Staff Report – August 13, 2013

814 North Charles Street

Mount Vernon Historic District

Plan: Construct eight-story building- Concept Review
Staff: Eric Holcomb
Applicant: Walter Schamu for Gould Properties

Photographs of existing parking lot

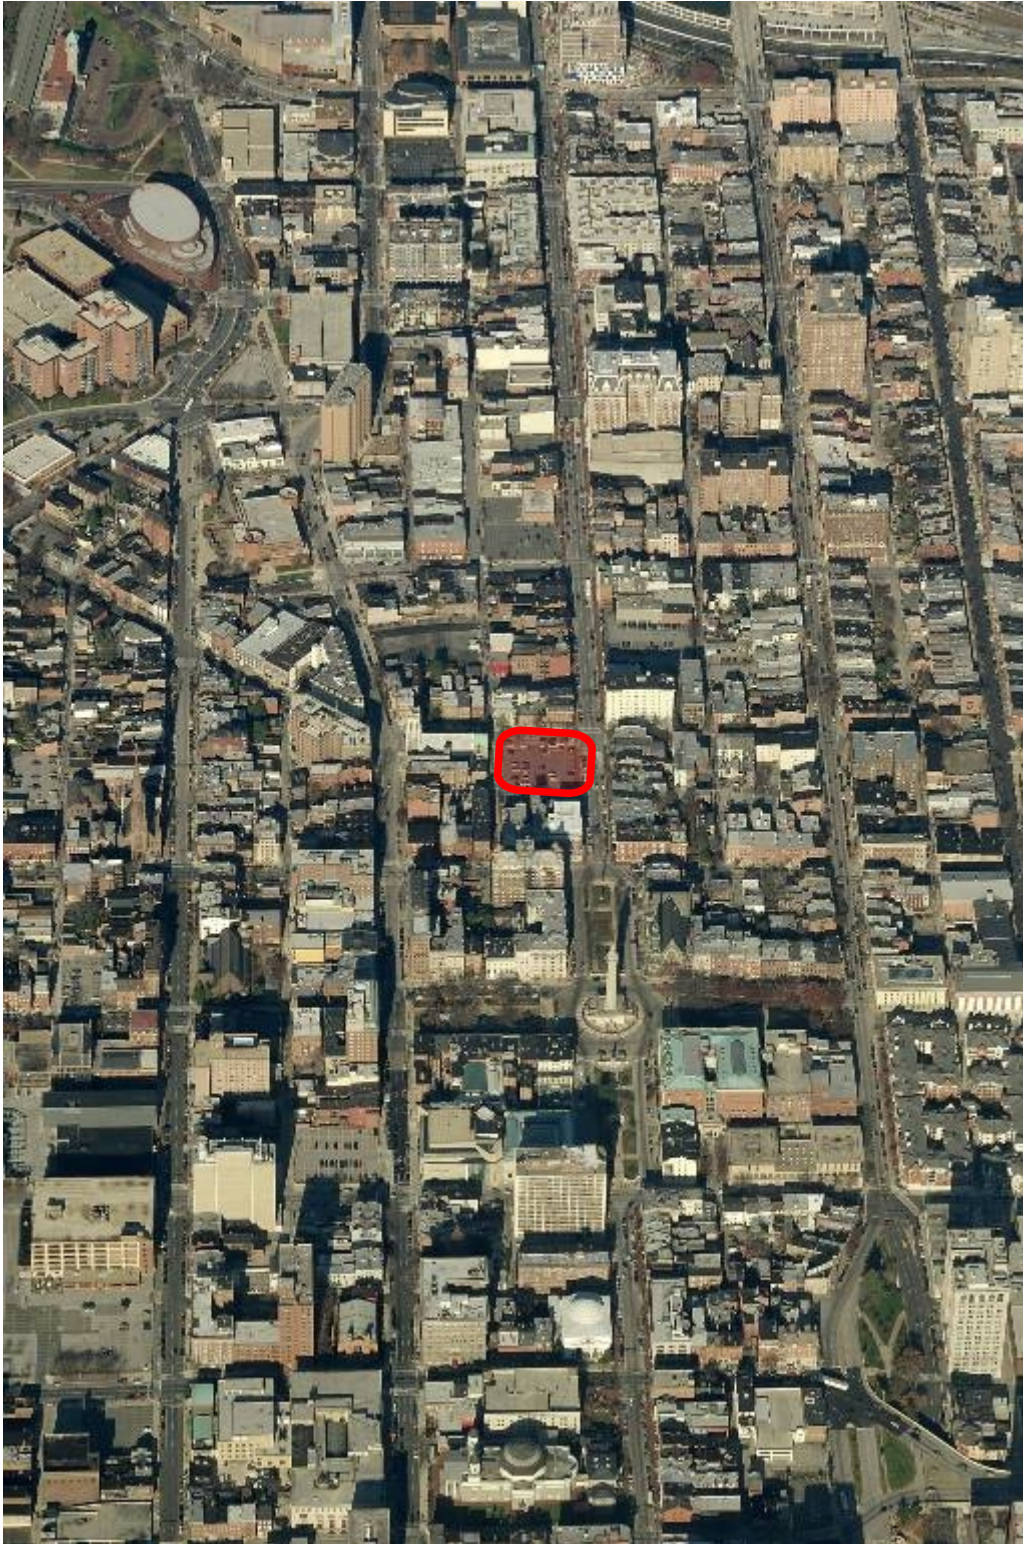
Background: 814 North Charles Street is located in the Mount Vernon local historic district on the southwest corner of Charles and Read streets. The site is approximately 160 feet long on Charles Street and 140 feet long on Read Street. It is currently a surface parking lot.
